STAFF REPORT

CASE NUMBER: P.D. 10-313 **L.U.C.B. MEETING:** October 14, 2010

DEVELOPMENT NAME: GERMANTOWN-KNIGHT ARNOLD PLANNED DEVELOPMENT, 2nd Amend

REQUEST: Plan amendment to allow a cellular communications tower one-hundred fifty(150) feet in height of concealed canister monopole design with a capacity to accommodate a minimum of five(5) antennae in Area ‘D’

Tower Site Plan

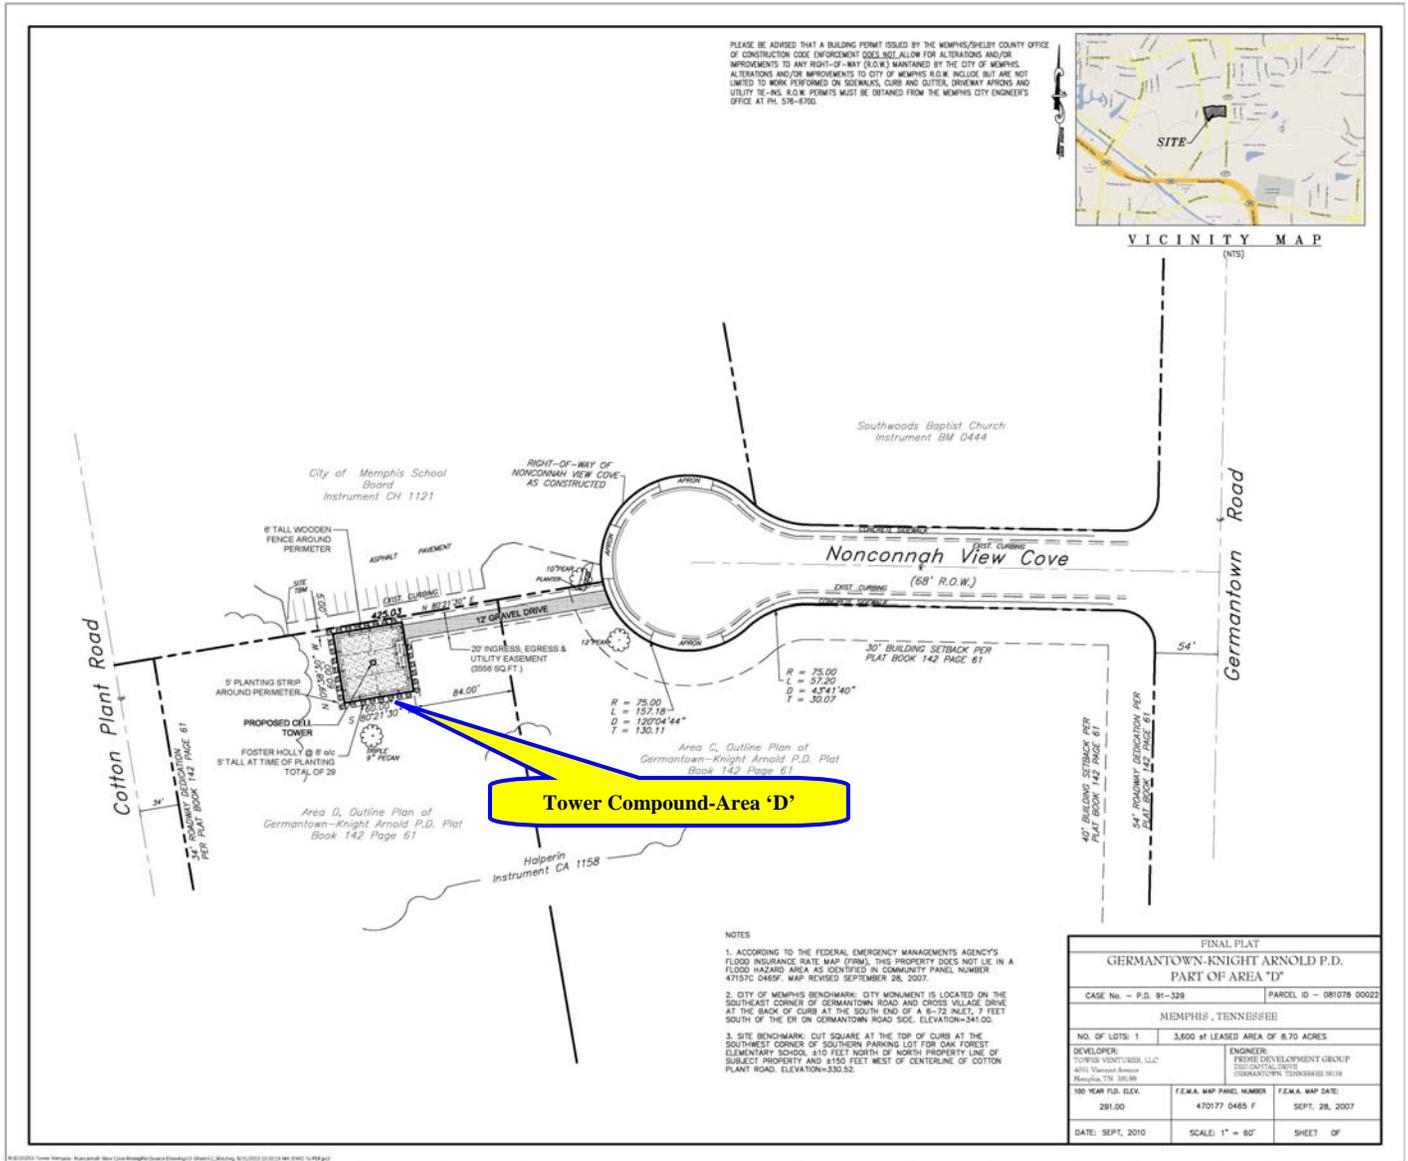
3. The placement of the tower in Area ‘D’ could possibly work against the future residential development of this tract and would place limitations on any residential development by complicating design standards.

4. The tower and compound should be located exclusively in Area ‘C’—the office parcel. The placement of the tower in Area ‘C’ would extend the horizontal separation to 400 feet from single family homes.

The tower and compound should be located exclusively in Area 'C'—the office parcel. Although residential is also approved in this area, it is more likely to develop as a small office plaza due to its location near a school and an apartment community. The design of the tower with concealed antennae would be more appropriate in a non-residential area, instead of being located in a future residential area within 260 feet of single family homes. The placement of the tower in Area 'C' would extend the horizontal separation to 400 feet from single family homes and place the tower exclusively in future non-residential development. This would alleviate the need for a new curb-cut for private drive access by utilizing the existing curb-cut at the south radii. Furthermore, the tower would eventually become an accessory structure to future principal office buildings with compound screening and landscaping.

5. This amendment to allow a cell tower of concealed canister monopole design in Area ‘C’ instead of Area ‘D’ is supported as an accessory structure with landscaping and compound screening.

- I. Landscaping for the tower shall be installed adjacent to the fence outside the leased area with shrubs of foster hollies planted eight(8) feet on center and five(5) feet at time of planting for a total of 29 plants with two(2) small tree Type 'C' or 'D' planted ten(10) feet on center along Nonconnah View Cove, subject to the approval of Office of Planning & Development.
